**City of Portland, Maine - Building or Use Permit Application**  
 389 Congress Street, 04101 Tel: (207) 874-8703, Fax: (207) 874-8716

**RE:** UnumProvident Centralized Mechanical Plant, Portland, Maine  
MacMillin Project WO1402  
BID NOTICE No. 3

**RE:** **Addendum No. Three (3) to the Bidding Documents for:**  
**UnumProvident 2003 Centralized Mechanical Plant**

**DATE:** July 17, 2003

SKE-3

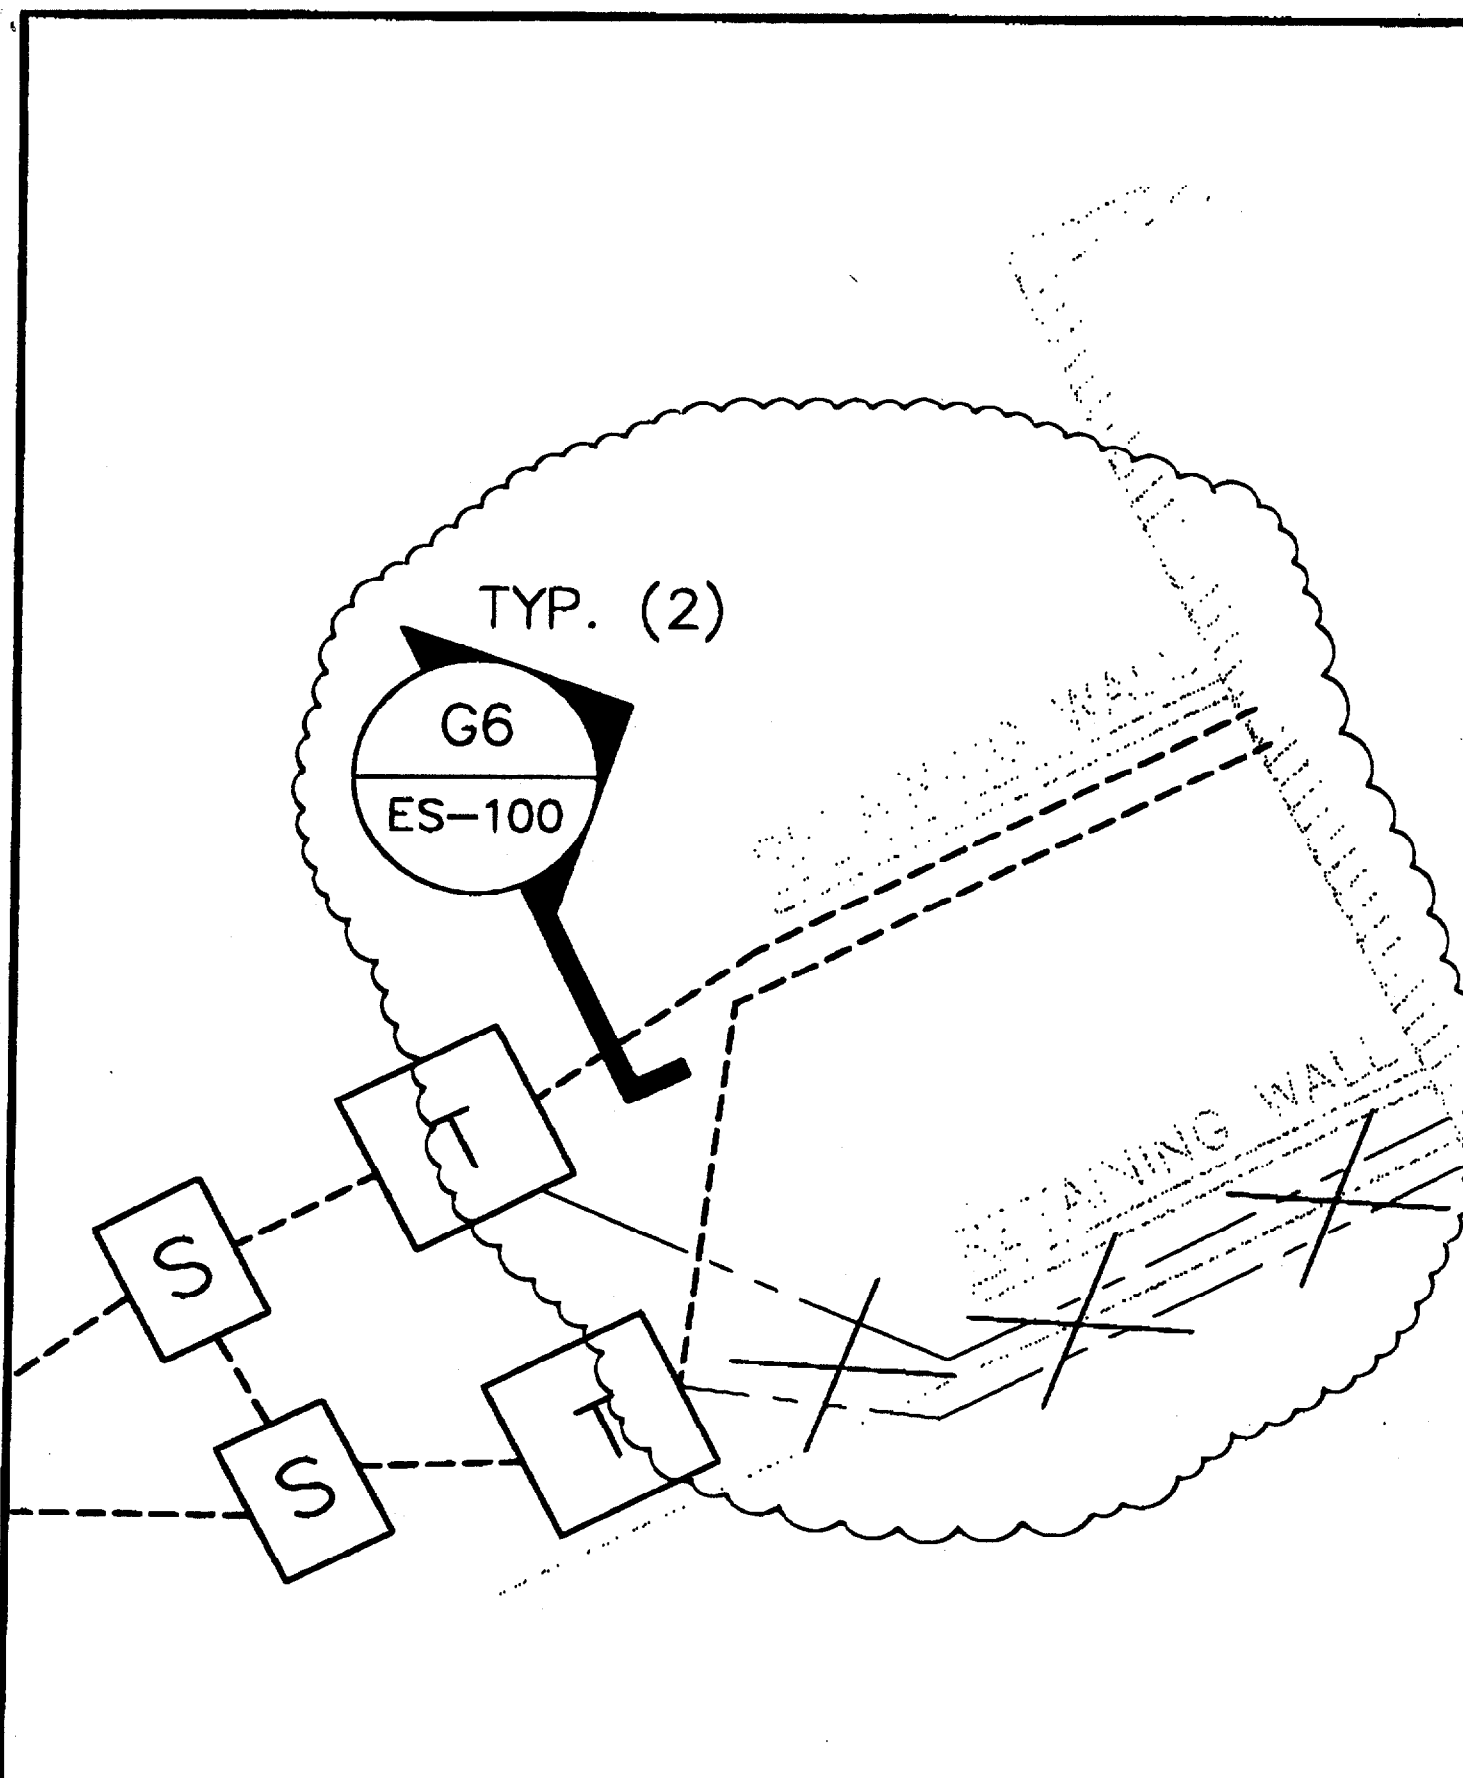
**Drawing ES-100:**

Refer to attached sketch SKE-3 for revisions. The work indicated on the sketch is included in the Base Bid and shall be deleted under Alternate #1.

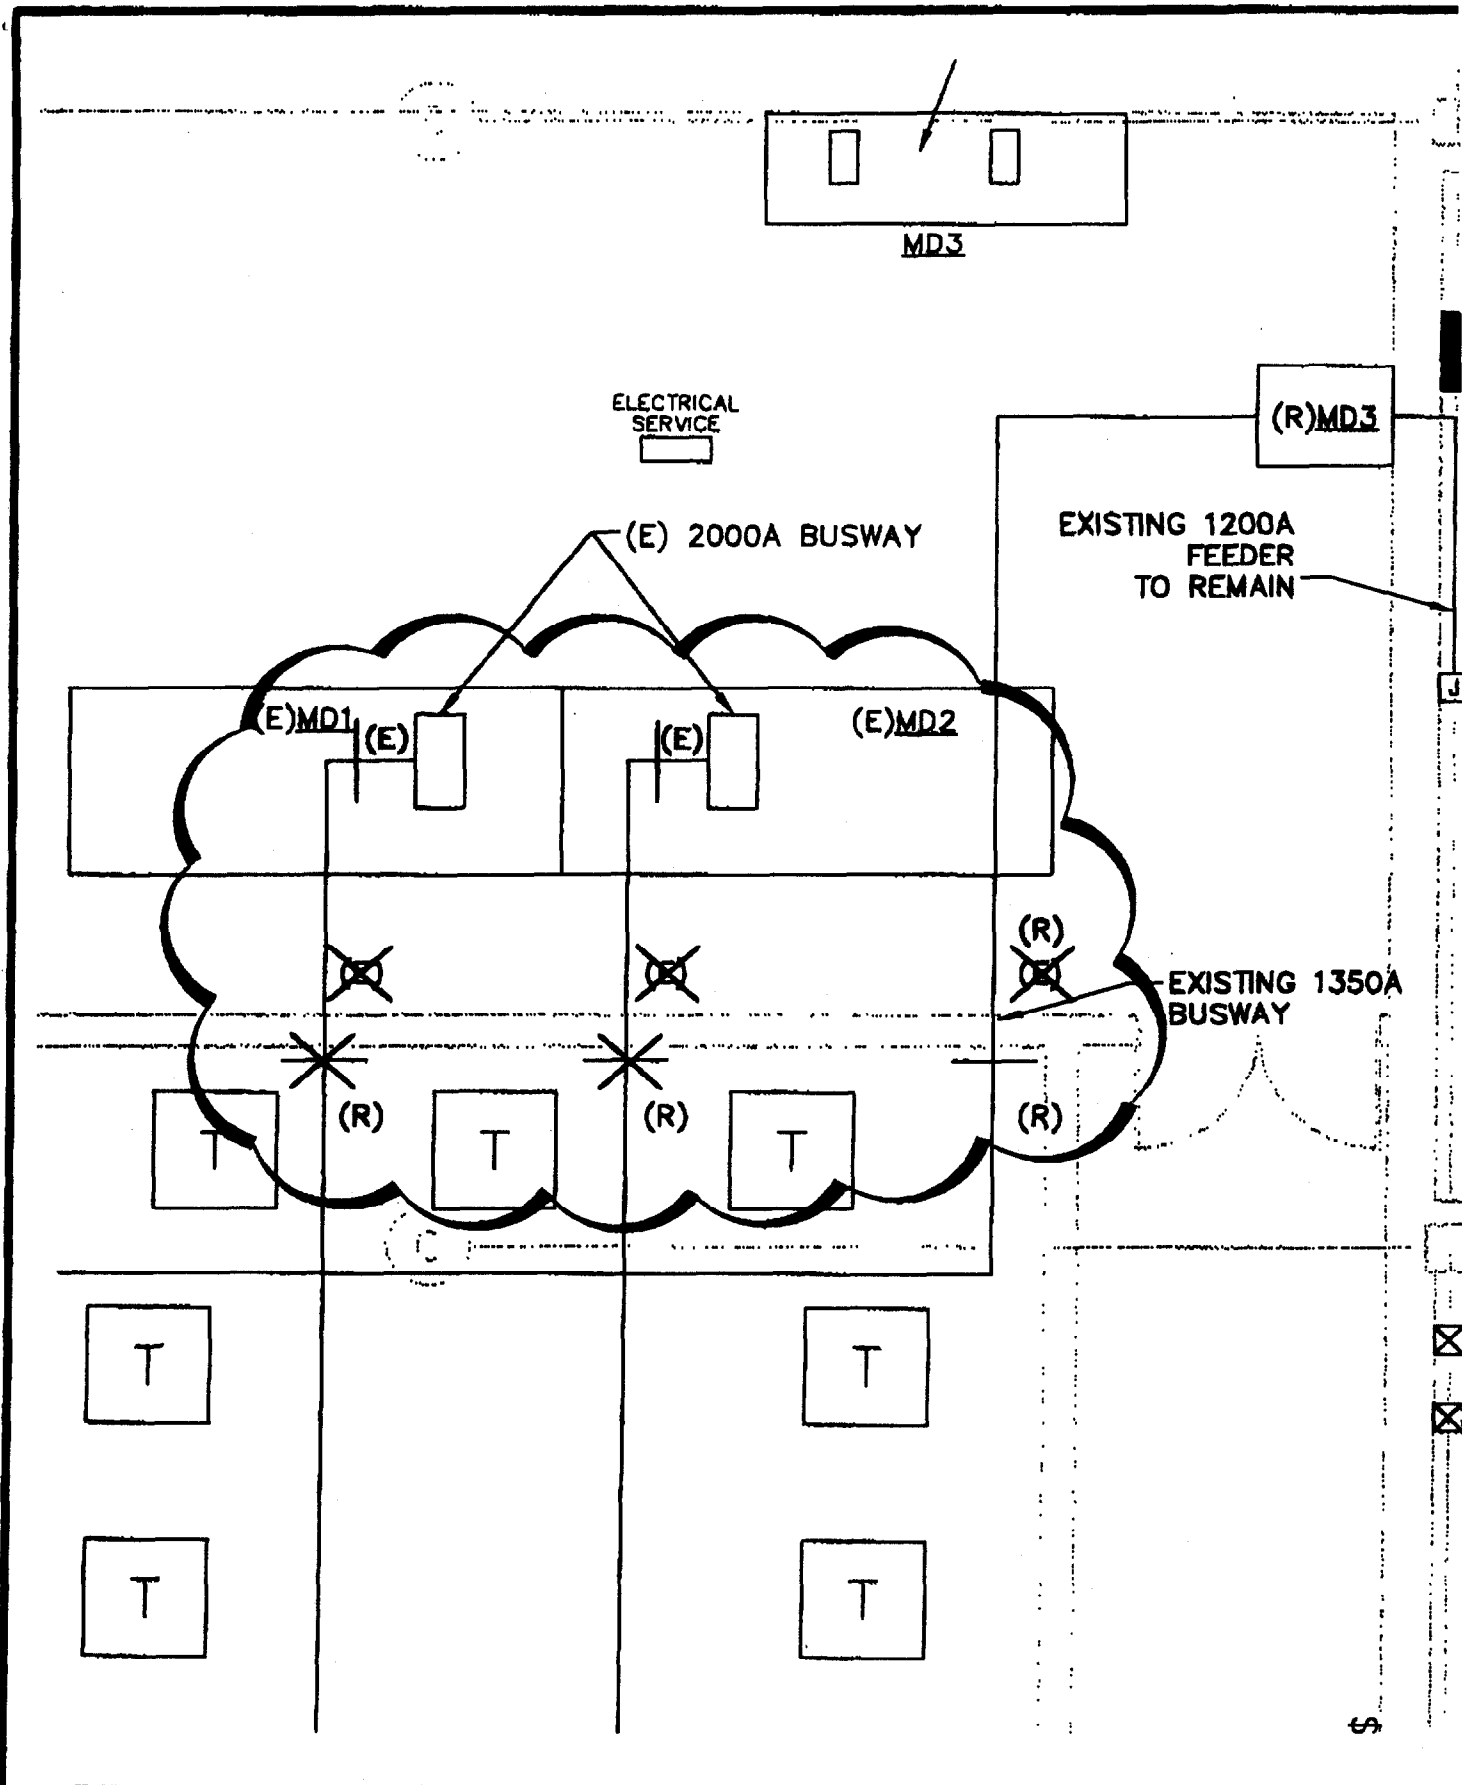
**Drawing ED-100:**

Refer to attached sketch SKE-4 for revisions. The work indicated on the sketch is included in the Base Bid and shall be deleted under Alternate #1.

SKE-5

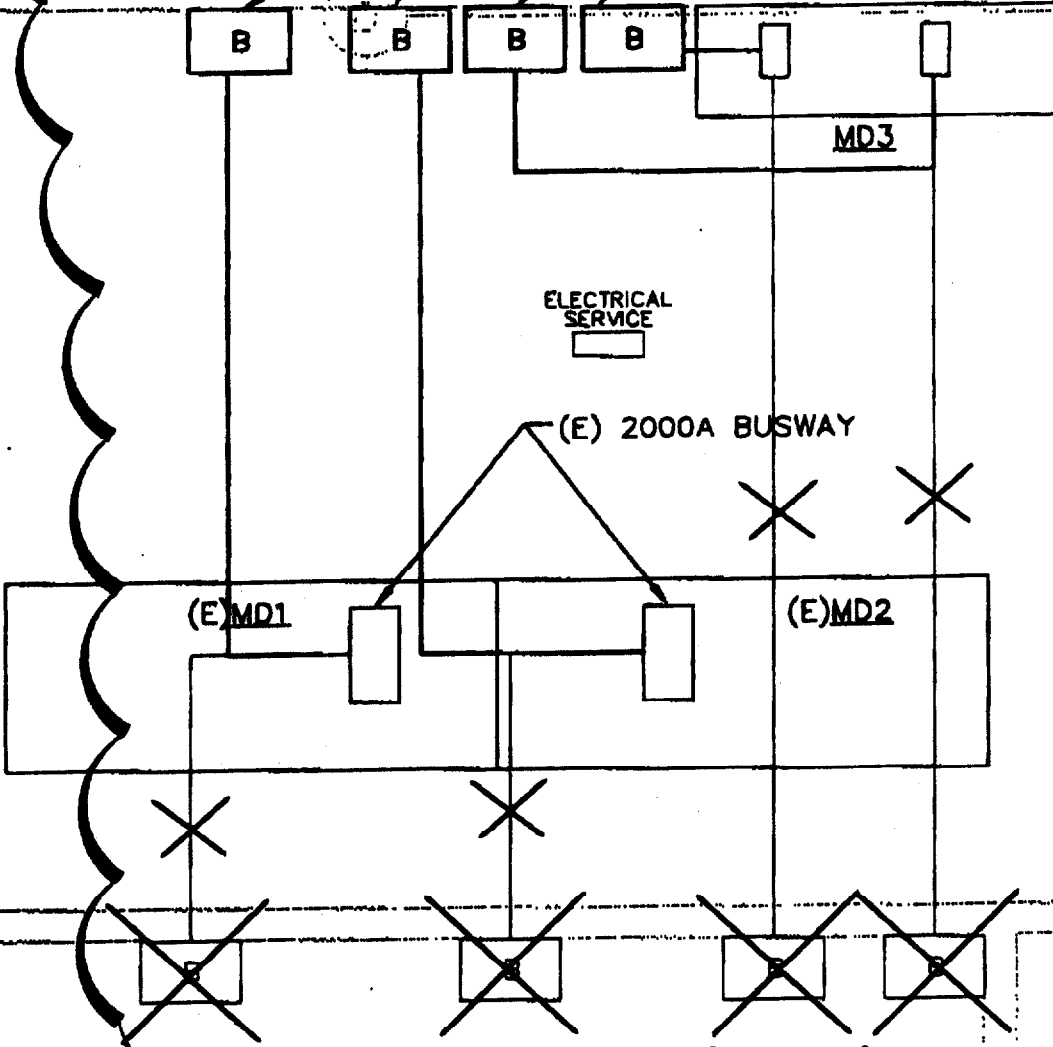
**Drawing E-100:**

Refer to attached sketch SKE-5 for revisions. The work indicated on the sketch is included in the Base Bid and shall be deleted under Alternate #1.

PROVIDE BUSWAY AND FEEDER CONNECTION BOXES ~ CONNECT TO EXISTING BUSWAY AND NEW SERVICE ENTRANCE CONDUCTORS.

PROVIDE BUSWAY FEEDER CONNECTION BOXES AND 1350A BUSWAY TO MATCH EXISTING ~ CONNECT TO MD3 AND NEW SERVICE ENTRANCE CONDUCTORS.
